**Rebuttal Proof of Evidence of Mr. Steven Bainbridge MRTPI  
On Behalf of the Appellant:  
Capital Community Developments Ltd.**

**A phased development of 75 dwellings, car parking, public  
open space, hard and soft landscaping and associated  
infrastructure and access**

**Land North Of Gardenia Close And Garden Square Rendlesham  
Suffolk**

**Our ref. PS-2018-0645/POE  
LPA ref. DC/19/1499/FUL  
PINS ref. APP/X3540/W/19/3242636  
Date: March 2020**

Originator	
Natural Building Design 29 Gardenia Close Rendlesham Suffolk IP12 2GX	
Project	Project No.
CC DEVELOPMENTS AREA 8 RENDLESHAM	
Layout Title	
EASTON SECTIONS & VIEW	
Drawing Number	Rev
84 / B16 / AS / T	F

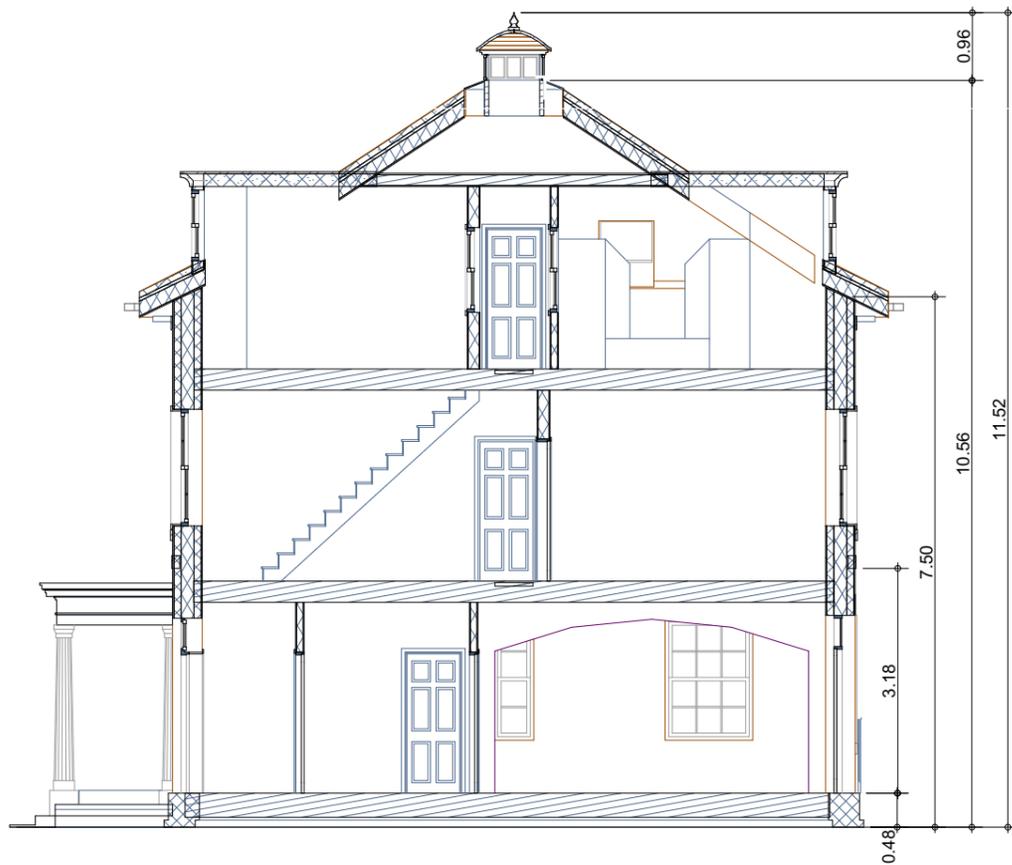
B2		<p>The first floor window on the north elevation of plot 33 serves a stair well and the enclosed drawing shows a cut through of a building with a similar arrangement showing that occasional views across would be limited. If required, it could be obscure glazed.</p>	Rooflights	<p>Rooflight cill heights are at 1.63m. The LPA has stated that it would be content with 1.7m height. If the LPA or Inspector find the 7cm difference material then the window positions can easily be raised up the roof slope to achieve 1.7m cill height.</p>
C1		<p>In this case the relationship between Plots 1 and 2 is comparable to no.s 29 and 30 Gardenia Close which were found to be acceptable in planning terms.</p> <p>Of the first floor windows on the north elevation of Plot 1; one is a bathroom window and should be obscure glazed. The other has been placed in the far corner of the bedroom and the relationship to the southern elevation window of Plot 2 is at an angle which affords slight views between rooms but is easily solved by obscure glazing the windows of either Plot 1 or 2 or both.</p>	Rooflights and half moon	<p>Rooflight cill heights are at 1.63m. The LPA has stated that it would be content with 1.7m height. If the LPA or Inspector find the 7cm difference material then the window positions can easily be raised up the roof slope to achieve 1.7m cill height.</p>

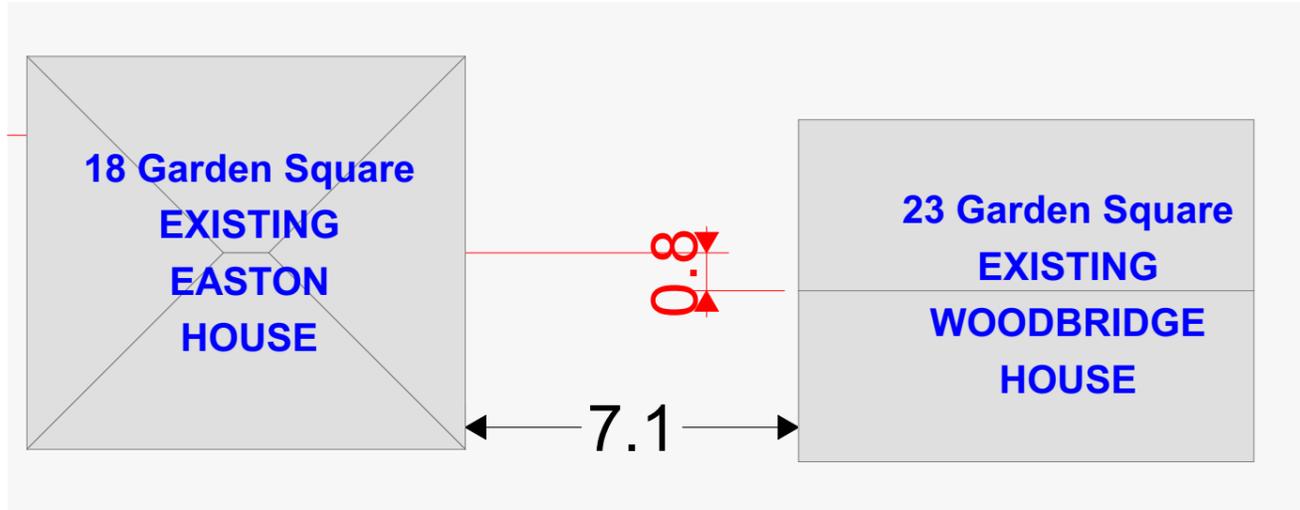
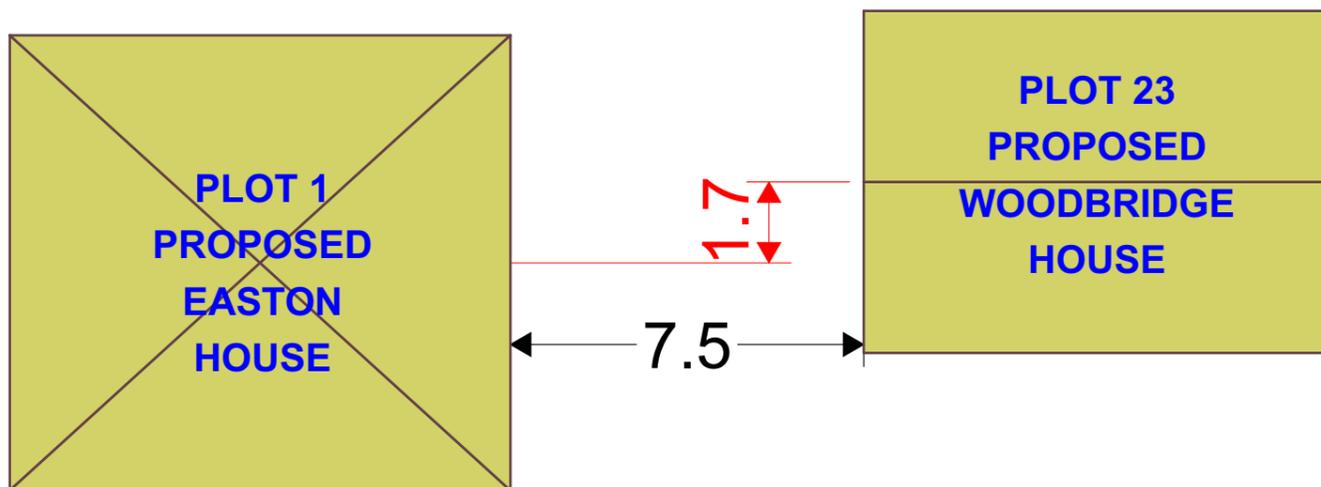
**NOTE**  
plots 29 & 28  
have a similar  
configuration  
to plots 1 & 2
